Access Compliance Report

Public Rights-of-Way

(Curb Ramps)

Intersection ID: 10039648	Main Street: THRIFTWOOD_DR	Cross Street: N/A	Location: E
ADA ID: 869BEE0983A9	Ramp Type: Perp	Initial Pass/Fail: Fail	Overall Compliance: No
Severity Score: 13.75			
Codes/Mitigation Info/Possible Solution		Field Measurements/Component Compliance

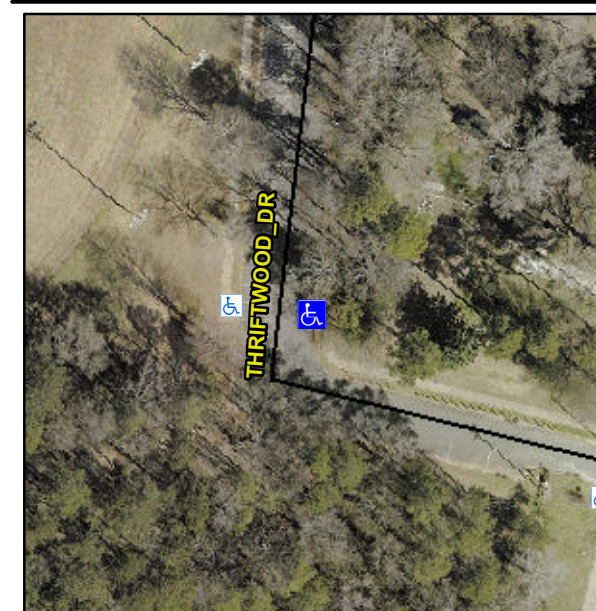
Not Found, R304.2.2, R304.5.3

Compliance	Description	Data	Compliance	Description	Data
N/A	Ramp Length (in)	48.0	No	Ramp Slope (%)	8.8
Yes	Ramp Width (in)	48.0	No	Ramp XSlope (%)	2.9
N/A	Flare Type LT	N/A	N/A	Flare Type RT	N/A
N/A	Flare Slope LT (%)	N/A	N/A	Flare Slope RT (%)	N/A
N/A	Flare Traversable LT?	N/A	N/A	Flare Traversable RT?	N/A
N/A	Landing Length (in)	N/A	N/A	DWS Provided?	N/A
N/A	Landing Width (in)	N/A	N/A	DWS Contrast?	N/A
N/A	Landing Slope (%)	N/A	N/A	DWS Length (in)	N/A
N/A	Landing X Slope (%)	N/A	N/A	DWS Full Width?	N/A
N/A	Landing Curb? (Y/N)	N/A	N/A	DWS Offset (in)	N/A
N/A	Shared Landing?	N/A			
N/A	Gutter Ponding?	N/A	N/A	Gutter Slope (%)	N/A
N/A	Gutter Lip Ht (in)	1.0	N/A	Gutter X Slope (%)	N/A
N/A	Painted X Walk1?	No	N/A	Painted X Walk2?	N/A
	X Walk 1 Direction	To W		X Walk 2 Direction	N/A
N/A	X Walk 1 Width (in)	N/A	N/A	X Walk 2 Width (in)	N/A
	X Walk 1 Slope (%)	3.8		X Walk 2 Slope (%)	N/A
	X Walk 1 X Slope (%)	2.8		X Walk 2 X Slope (%)	N/A

Remove & Replace Entire Ramp.
